2 - PORTALS - 18PA1
(END PORTALS @ U1 & U1')

Vermont Agency of Transportation
RECEIVED
CK'D BY TCF OK'D BY SSS
7:43 am, Apr 12, 2011
RESUBMIT _____ APPROVED X
BY KMH DATE 4-12-11

MATERIAL:	M270-50 (U.N.)	SURFACE PREP. & PAINT:	SEE DWG GN1	HOLES:	1/8"	SHOP BOLTS:	AS NOTED
DESCRIPTION:	PORTALS						
CASCO BAY STEEL STRUCTURES, INC.							
75 SPRING HILL ROAD				SACO, MAINE 04072			
PHONE (207) 282-7360				FAX. (207) 282-1179			
STRUCTURE:	Vermont Route 100A Bridge No. 14 Bridgewater County of Windor			DRAWN:	RB	DATE:	10/7/10
				CHKD:	WJL	DATE:	10/19/10
LOCATION:	BRIDGEWATER, VERMONT			JOB NO.	18AB		
PROJ NO.	BRS 0149(4)			454	REV. 18AB		
CUSTOMER:	VT AOT

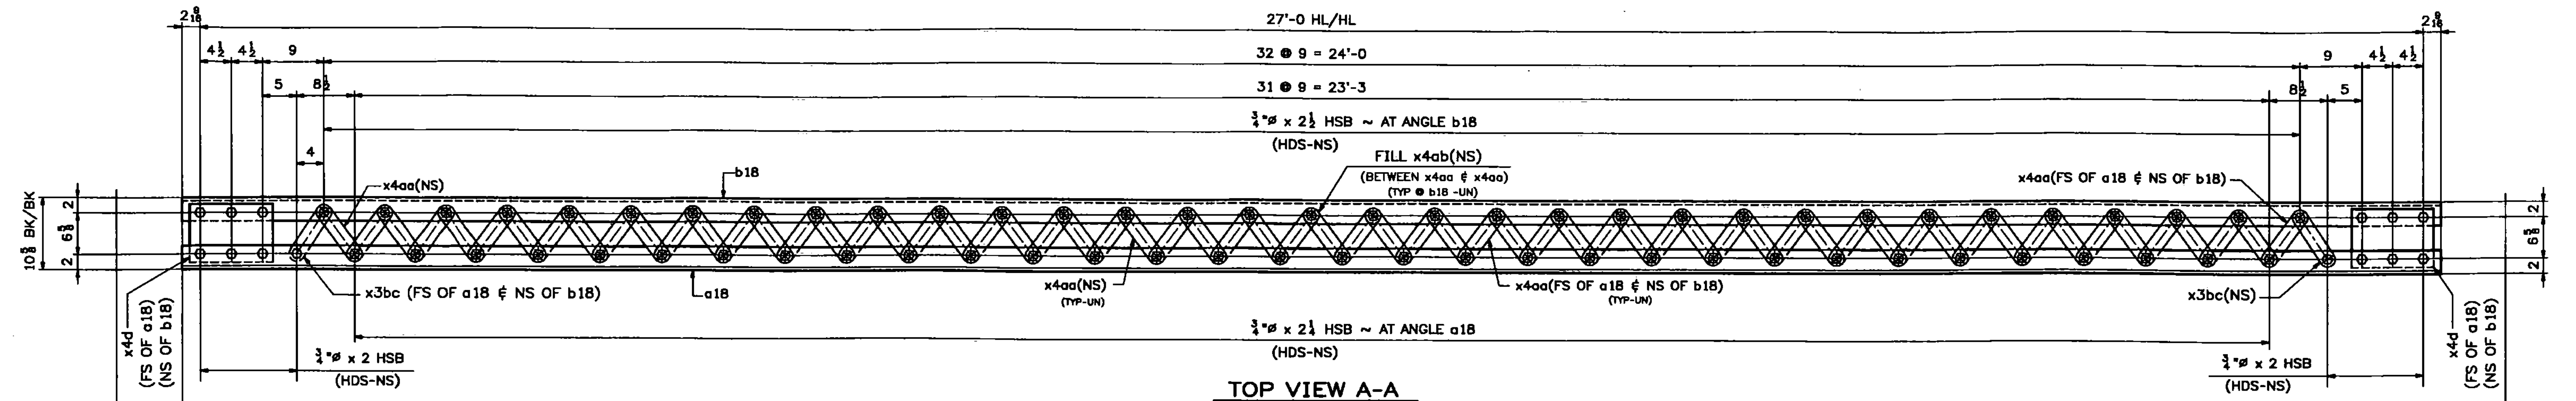
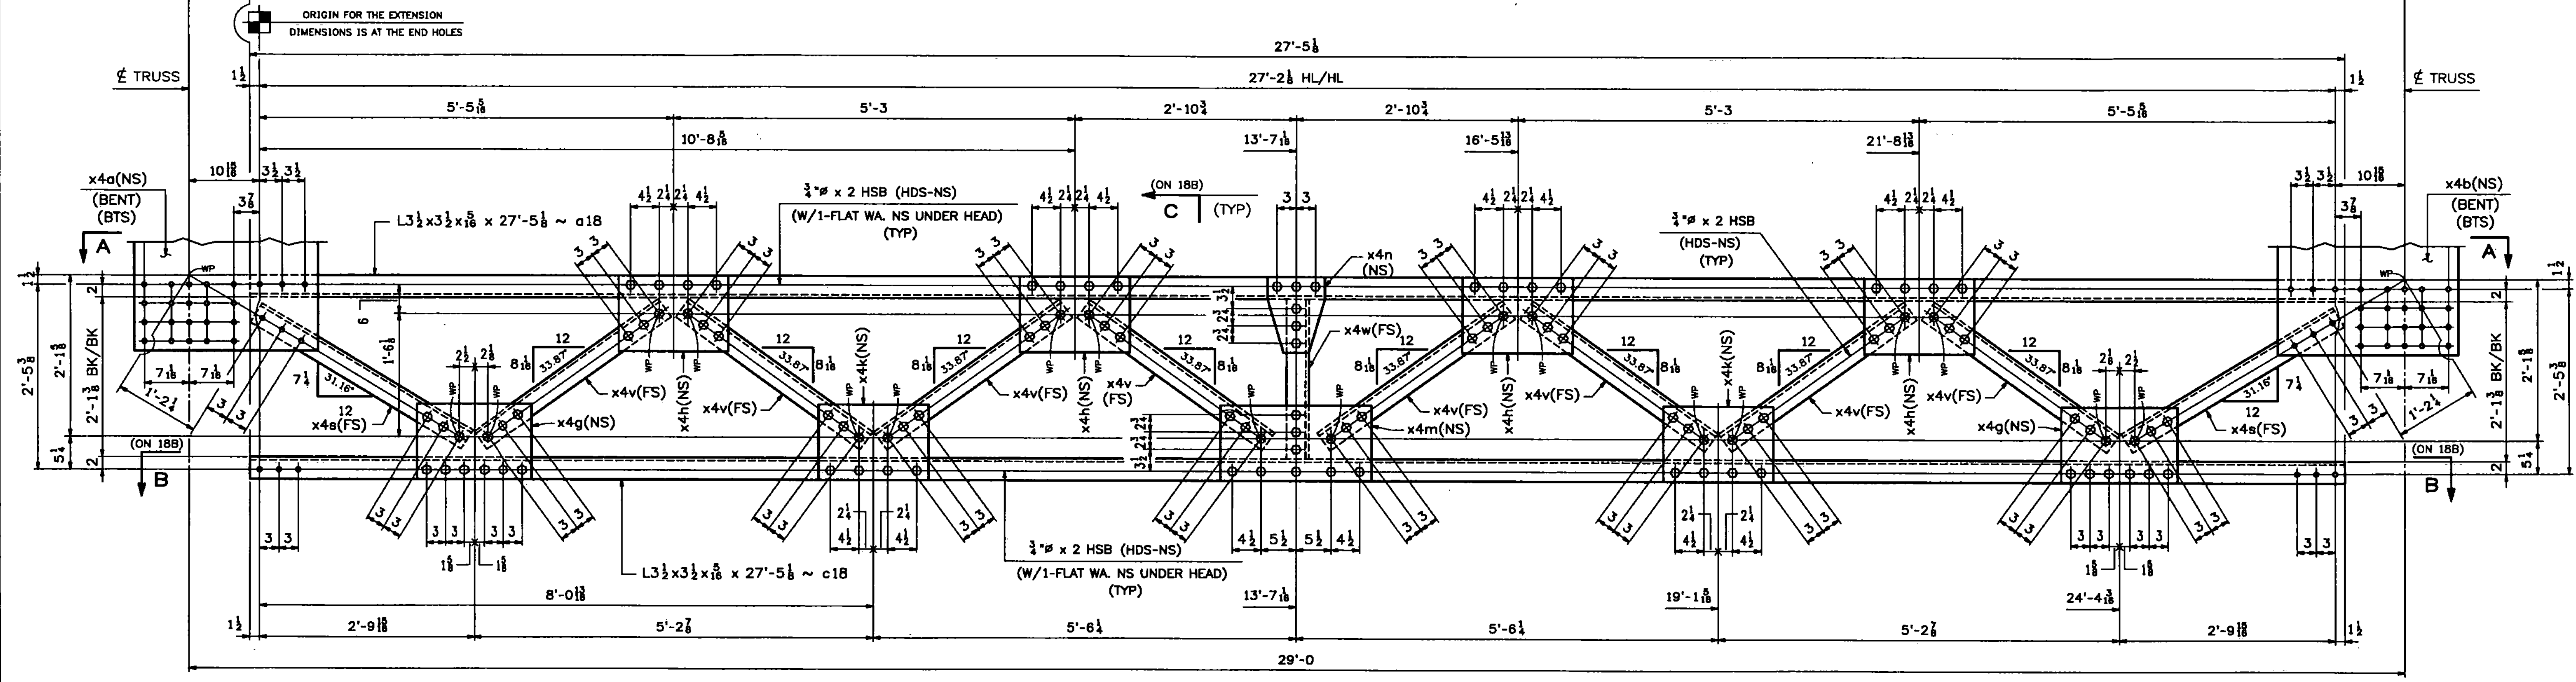
REV.	DATE	REMARKS	DWN	CHK	APVL	SHOP
1	03/24/11	REVISED BEVELS & ANGLES	JM	PWR		
2	03/02/11	REVISED AS PER APPROVAL COMMENTS	JM	PWR		
0
